IEEE P802.3at Task Force

Power Via MDI Enhancements

Simultaneous Operation of ALT A and B

March 19 2008

PSE section: 33.2.2 Page 22 line 49-52:

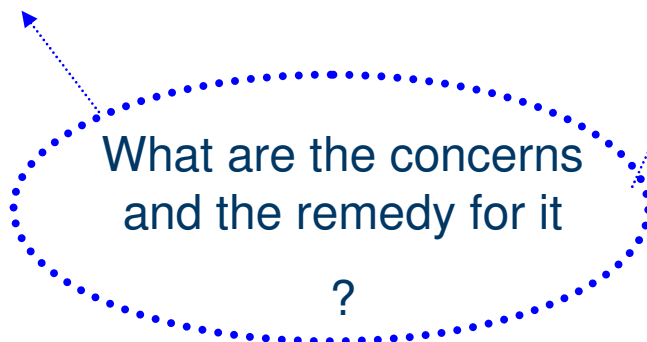
A PSE shall implement Alternative A or Alternative B, or both, provided the PSE meets the constraints of 33.2.3. Implementors are free to implement either alternative or both. While a PSE may be capable of both Alternative A and Alternative B, ~~PSEs shall not operate both Alternative A and Alternative B on the same link segment simultaneously.~~ simultaneous operation of Alternative A and Alternative B is out of scope of the standard.

NOTE—PDs that implement only Mode A or Mode B are specifically not allowed by this standard. PDs that may simultaneously receive ~~require~~ power from both Mode A and Mode B are ~~specifically not allowed by~~ out of scope of this this standard.

Comments for Figure 4-1

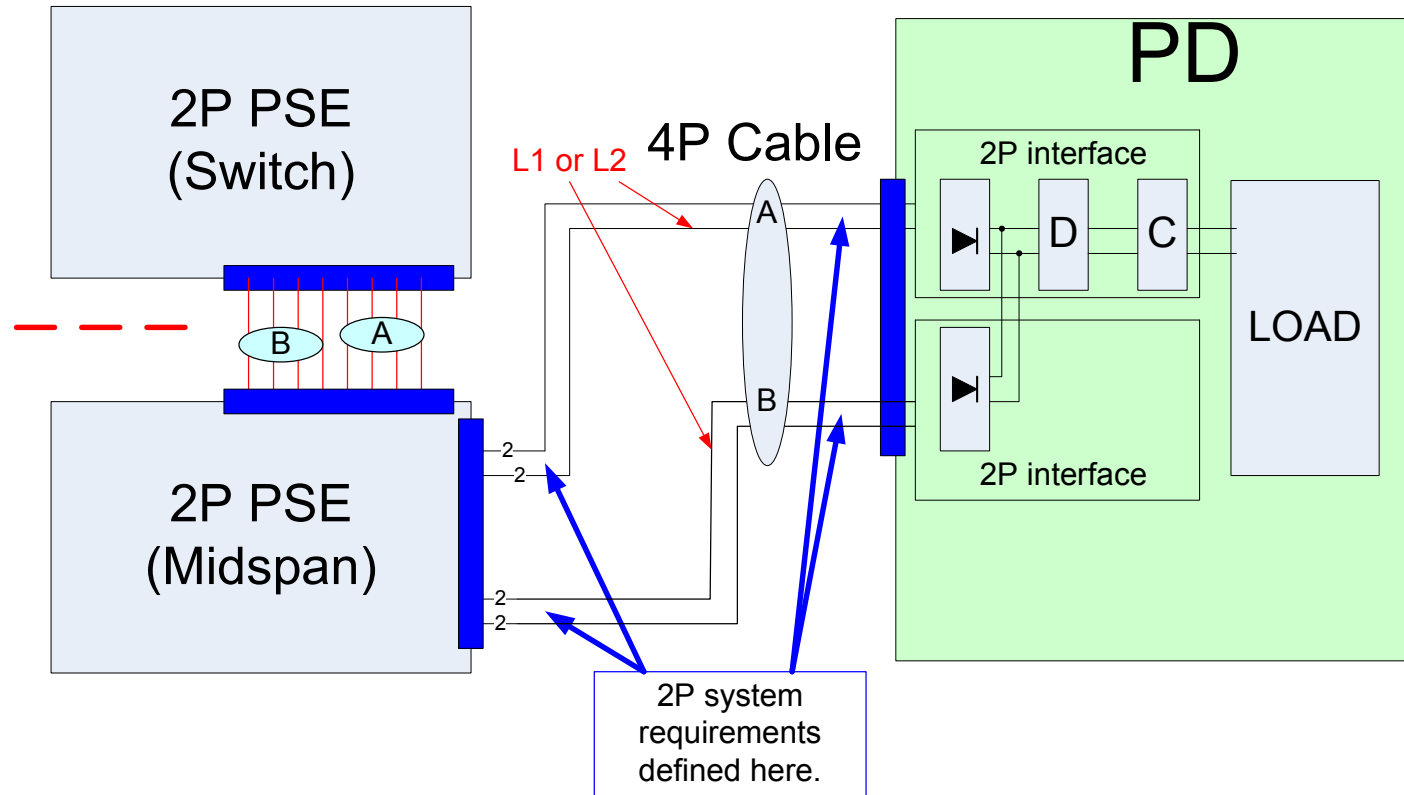
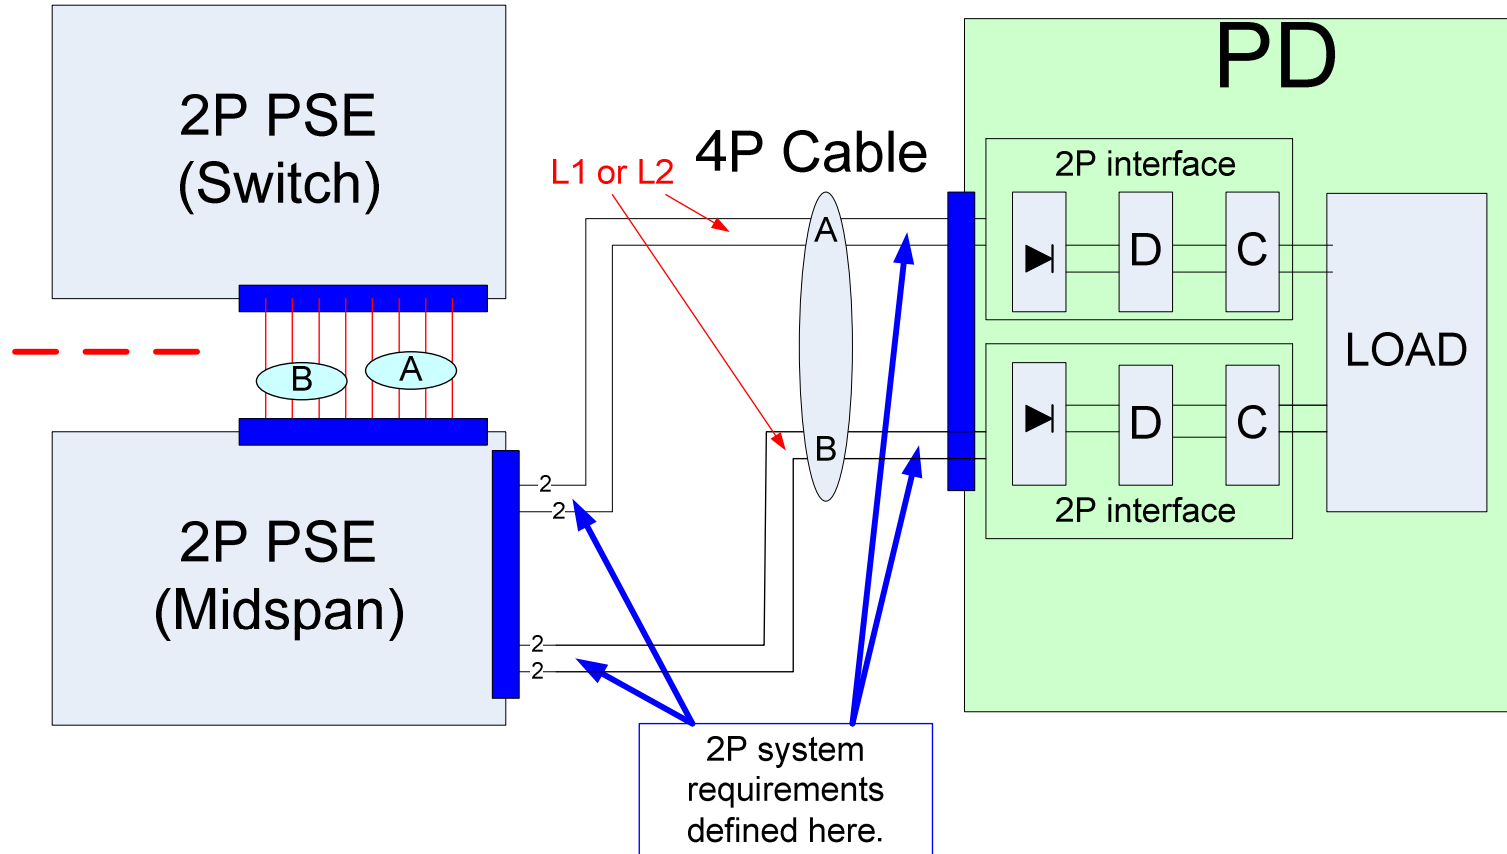
- The following Midspan-Switch Combination is not expressly forbidden. This type of configuration is addressed by the back off function for allowing the Switch to have priority in powering.

- If we want to use it as 2x2P configuration, it would only work if all switches use ALT A. See later in the percentage of ALT A switch in the market.
- This input is relevant only if we require 2x2P PD to work only with 2x2P interface. If that PD designed to work in dual mode, then it doesn't matter.

- If 2 separate source (Switching Power Supplies) are used in Midspan and Switch there are known potential unreliable operation when PD does not have isolation (Functional Isolation. It is not a safety issue) between A and B sources.

- In this configuration we could have failures to detect legal PDs and false disconnects. The route cause is the common mode EMI corrupting the detection and measured values for current. It is possible that a good Midspan, a good switch and good PD that play well but fail in the configuration without functional isolation.
